**MEETING OF THE DESIGN REVIEW BOARD
MORRIS N. BROAD COMMUNITY CENTER
1175 95TH STREET
BAY HARBOR ISLANDS, FL 33154**

REVISION # 1 REVISION DATE: 07/18/23

Subject: Site Development Plan Application - Revision
Proposed New 9 DU Multifamily Residential Complex
Revisions to Approved Site Development Plan
1055 93rd Street
Bay Harbor Islands Acct. No. SPR22-000026
MMPA Acct. No. 01-0702-1144

Revision to Approved Planning and Zoning Board Submission

Sheet A-14, Level 4 Floor Plan

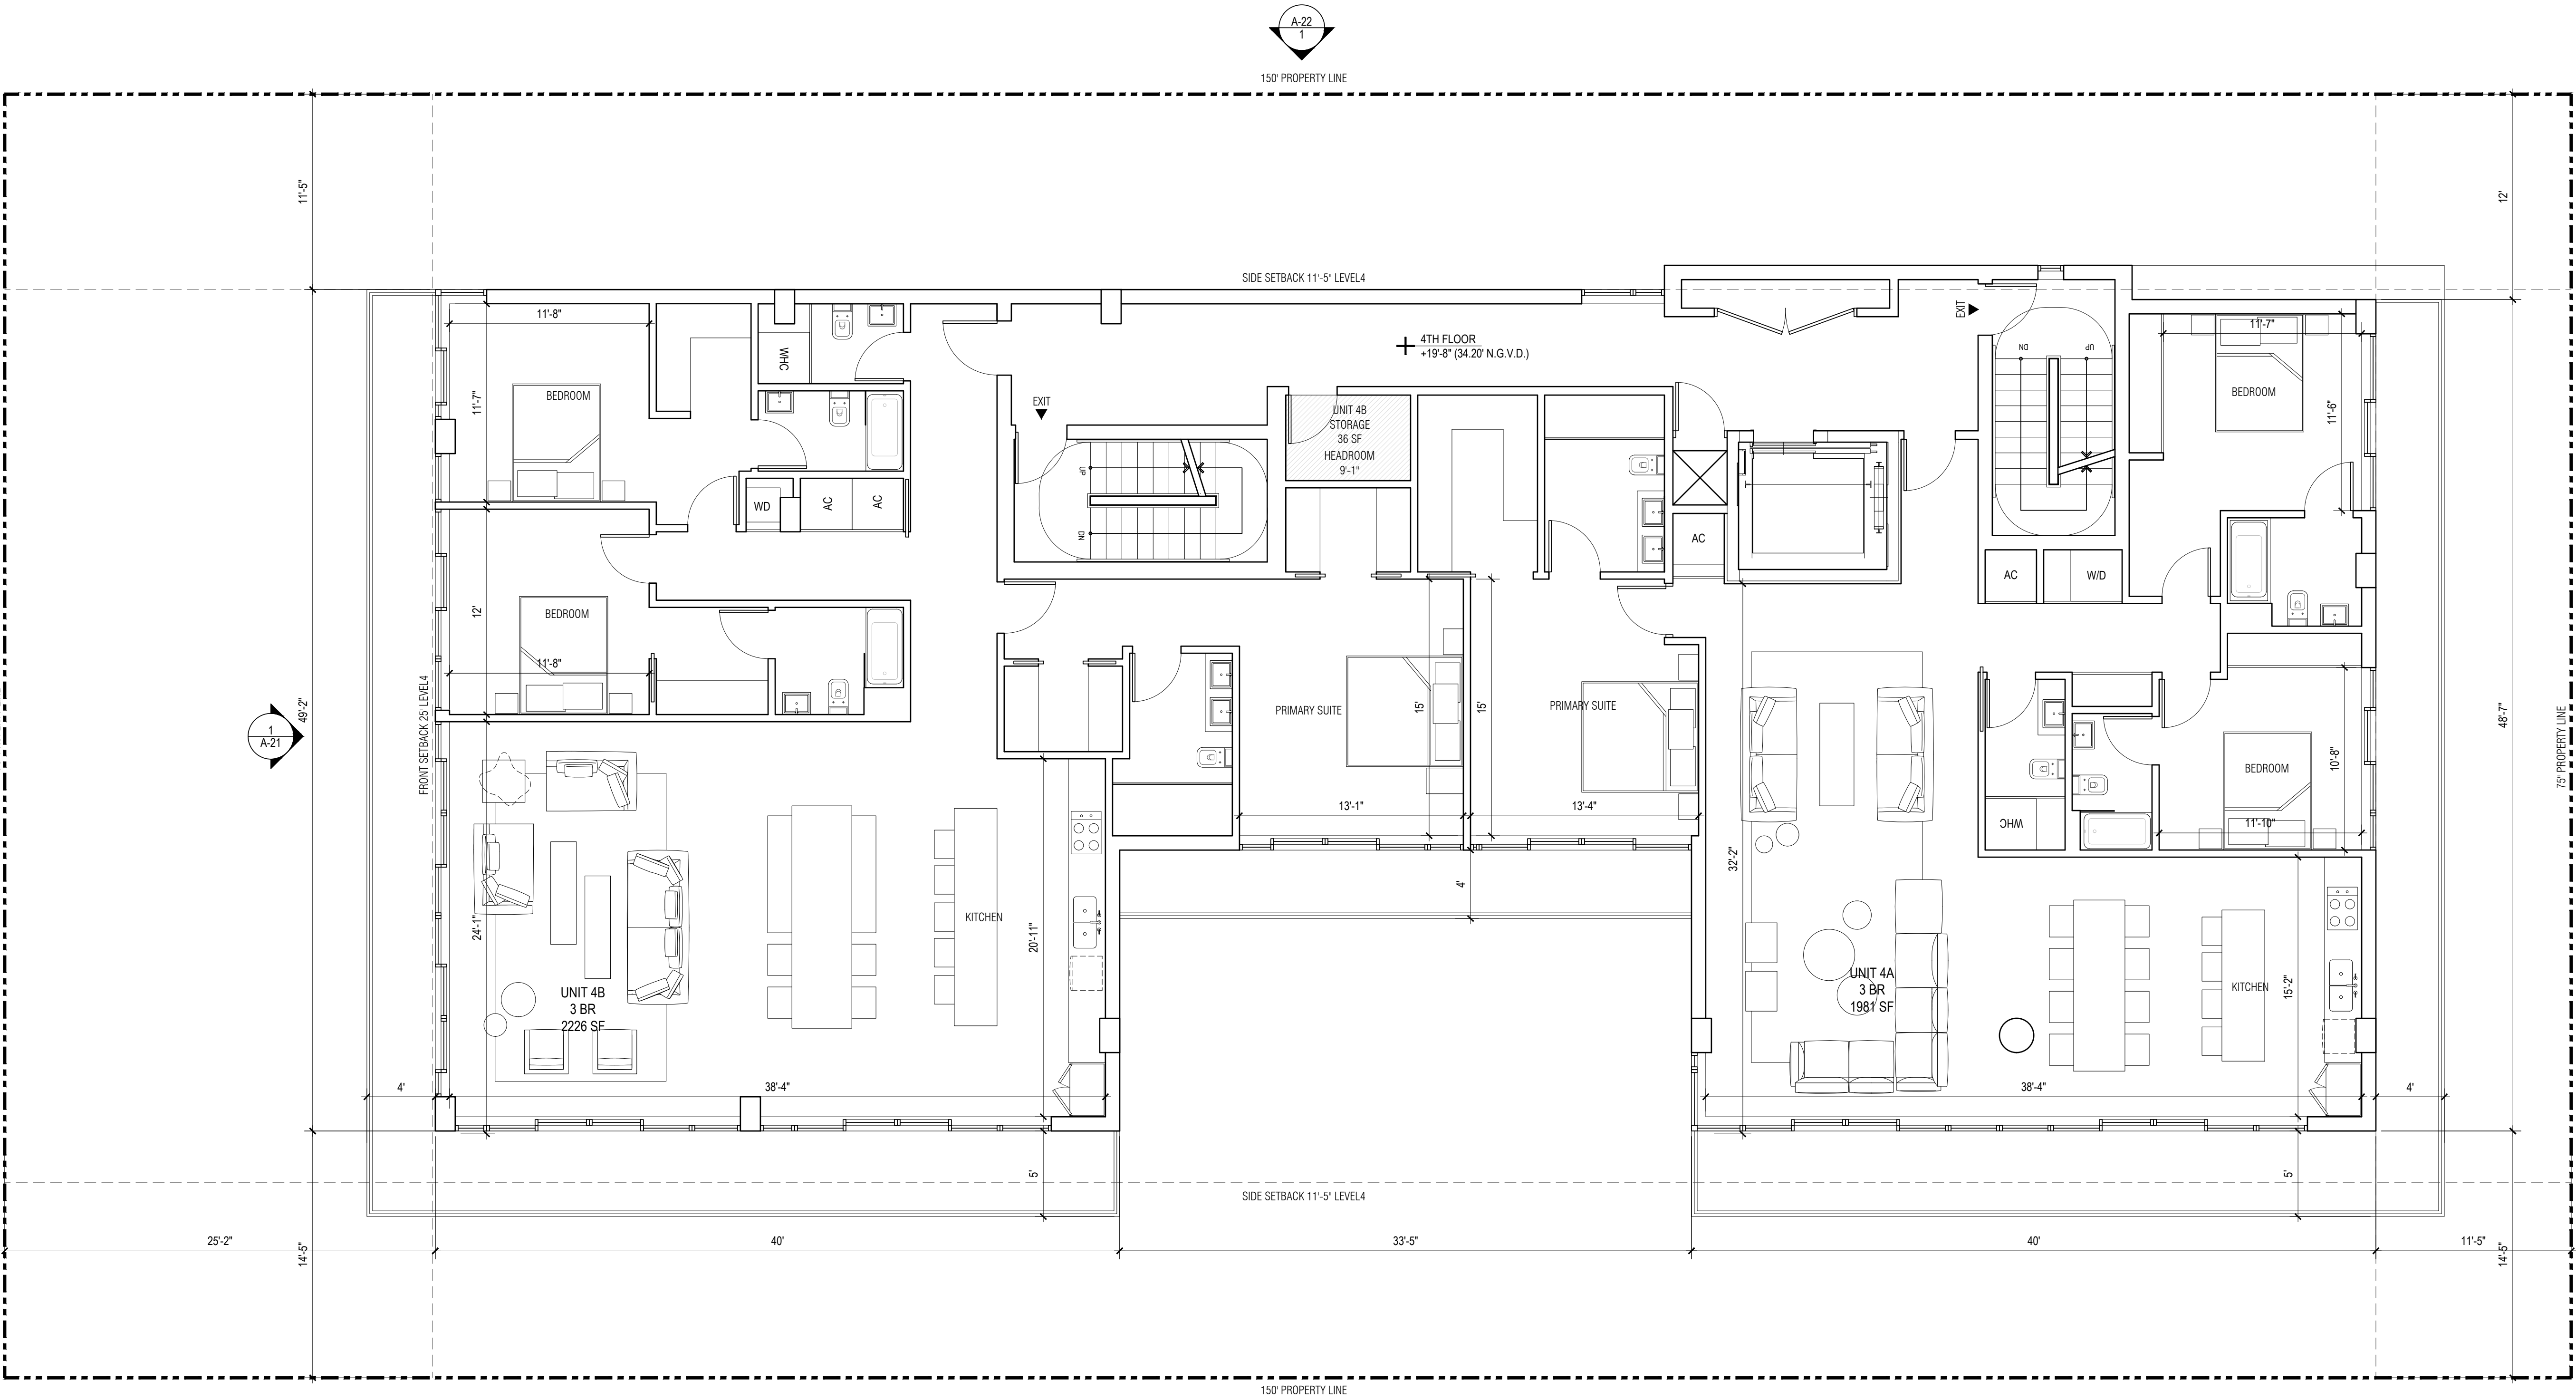
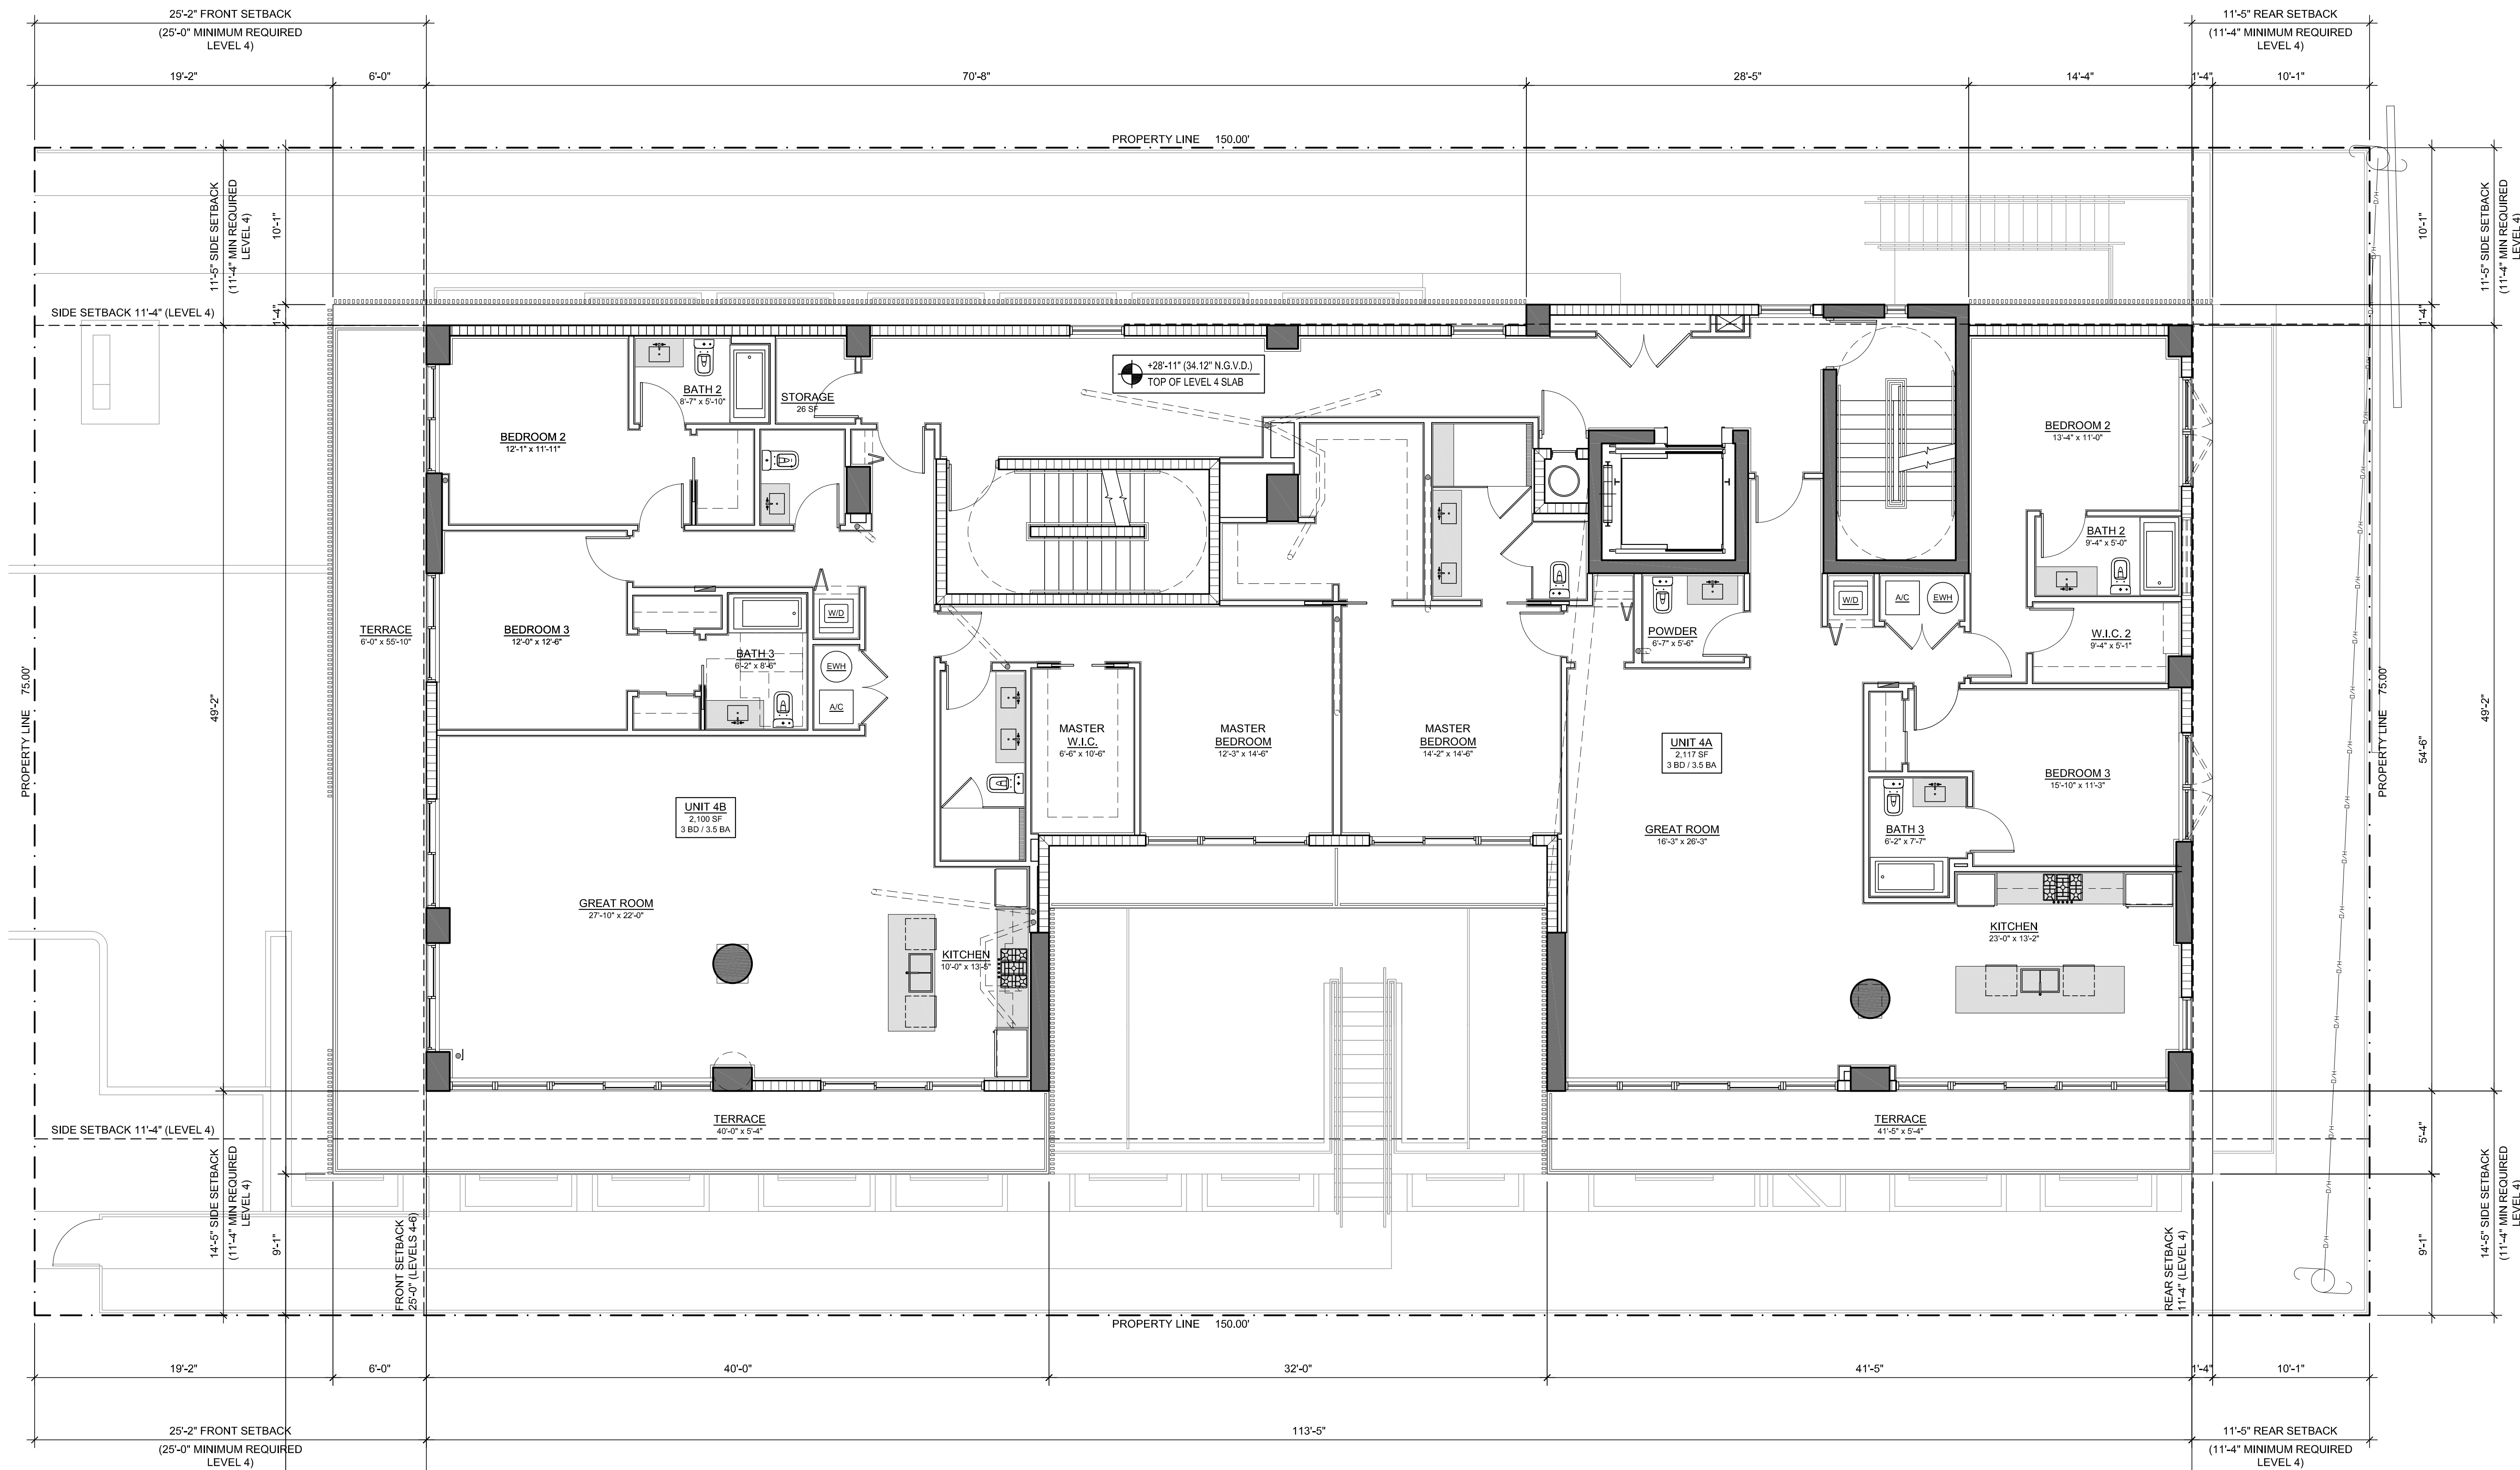
1. Modifications to the floor plan to remove the north facing balcony along the rear elevation due to the proximity of the FPL power lines that are running along the rear property line
2. Modifications to the exterior window/door placements and sizes due to changes to the unit layouts and coordination with Structural
3. Modifications to the interior unit layouts
